Hi-Fi Products
Service Bulletin

Model: D-4140/T4/T40

No. 289

Subject: Caution When Replacing IC801

If you change IC801

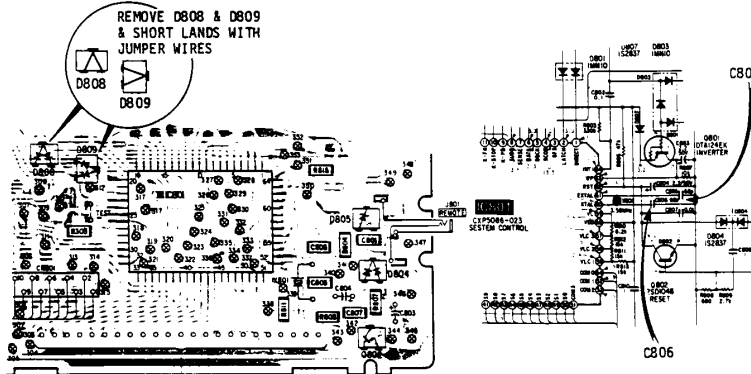
DESCRIPTION	PART NUMBER
FORMER IC	CXP-5086-026Q	8-752-804-07
NEW IC	CXP-5086-602Q	8-752-809-23

1. Remove D808 and D809 and then short the lands for those diodes.
2. Change the value of C805 and C806 from 68pF to 47pF.

REFERENCE	DESCRIPTION		PART NUMBER
	FORMER	NEW	
C805 & C806	68pF	47pF	1-163-109-00
